## SITE PLAN REVIEW AND APPEARANCE BOARD STAFF REPORT

Pierre Delray II

Meeting	File No.	Application Type
January 25, 2022	2022-080-SPM-SPR-CLIV	Class IV Site Plan
Property Owner		Agent
Pierre Delray Two LLC		Dunay, Miskel, Backman LLP

Consideration of a Class IV Site Plan Modification to expand the previously approved three-story mixed-use building with parking garage at 298 East Atlantic Avenue to incorporate the parcel to the south.

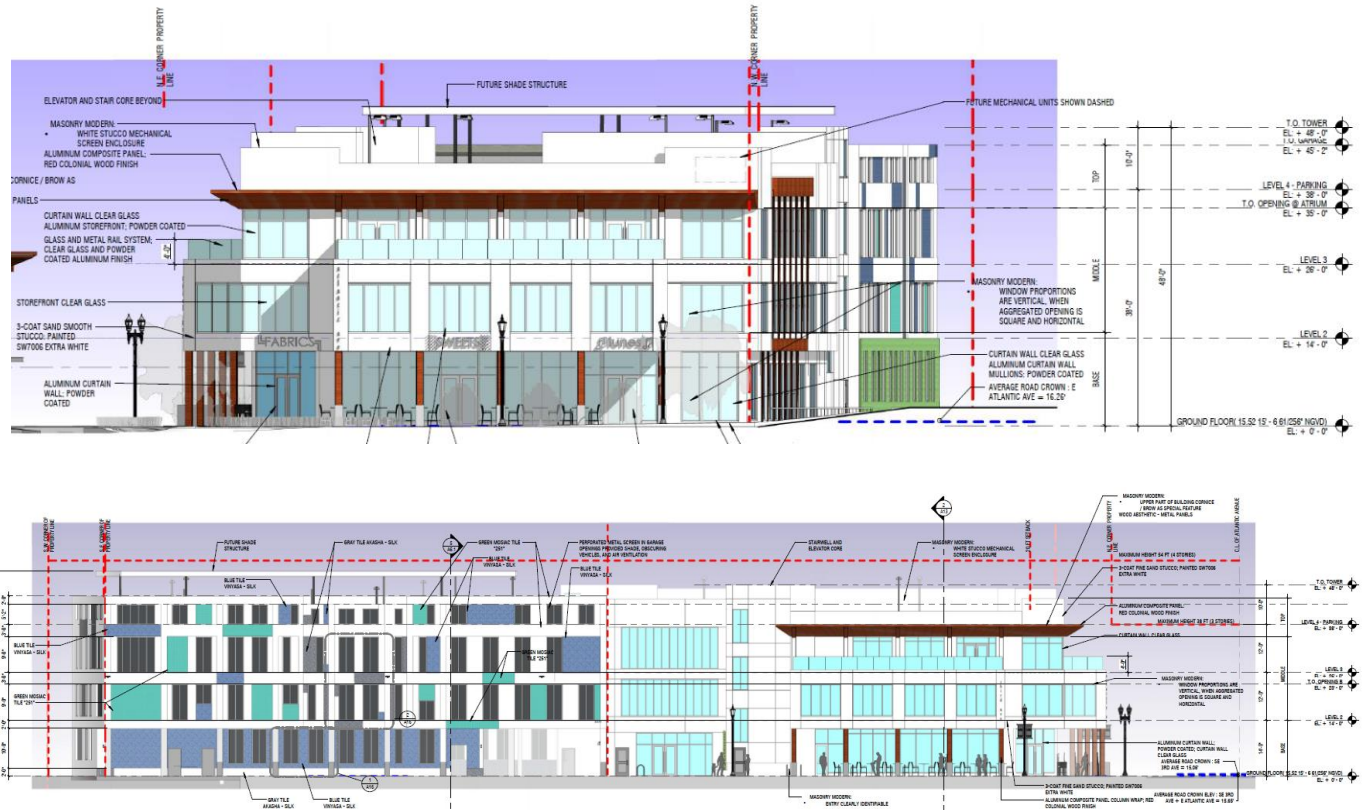
The proposed frontage elevations provided below have been reviewed for compliance with both Section 4.6.18(E), above, and the architectural standards in 4.4.13(F).

The overall architectural design language, which is consistent with what was approved as part of the original Class V site plan approval, is found to be consistent with all applicable aspects of the Design Guidelines with respect to architectural style, materials, treatments, proportions, and composition. The applicant is proposing a masonry modern architectural style that utilizes stucco, large glass panel window openings, wood treatments, and mosaic decorative tile; and incorporates shifts and recesses in the massing to deliver a composition that is consistent and compatible with the surrounding area and enhances the quality of the pedestrian realm. Staff does not find any conflict between the criteria listed above and the proposed design.
